Memorandum

TO: Columbia River Crossing Task Force
FROM: CRC Pedestrian and Bicycle Advisory Committee (PBAC)
SUBJECT: PBAC Recommendations for World Class Pedestrian and Bicycle Facilities

Purpose of this Memorandum

PBAC Proposed Pedestrian and Bicycle System for Replacement Bridge

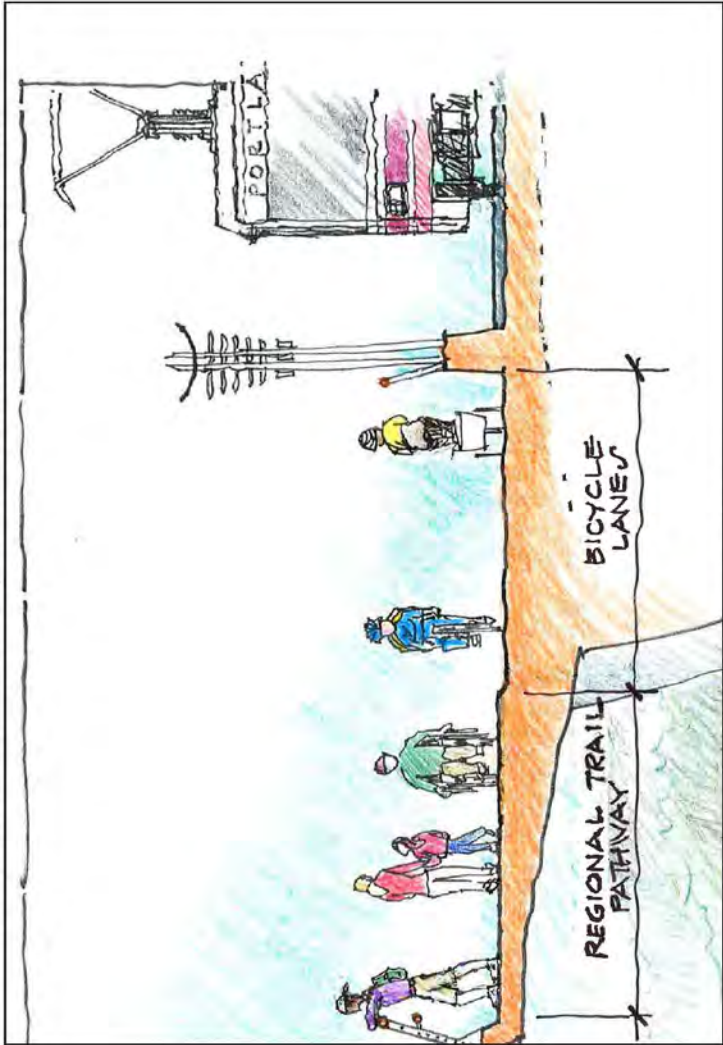
- The overall pathway on the western bridge (adjacent to the transit guideway) must provide separation between recreational users and higher speed bicycle users. To provide this separation, a 12-foot wide regional trail should be provided adjacent to, and to the west of, a pair of six-foot wide bicycle lanes (see attached rendering). These recommended widths are exclusive of potentially needed shy distances, i.e., free and clear of poles and other obstructions to enable safe pedestrian and bicycle movement (a summary of agency standards for multiuse paths, sidewalks and bike lanes is attached).

- In addition to the combined regional trail and bicycle lanes on the western bridge, an eight-foot wide sidewalk should be provided on the eastern bridge (the bridge that would serve the northbound traffic lanes) across both the Columbia River and the North Portland Harbor. The sidewalk across the North Portland Harbor would touch down on Hayden Island and use surface street sidewalks to connect to the sidewalk across the Columbia River.

Please see response to comment G-001-003.
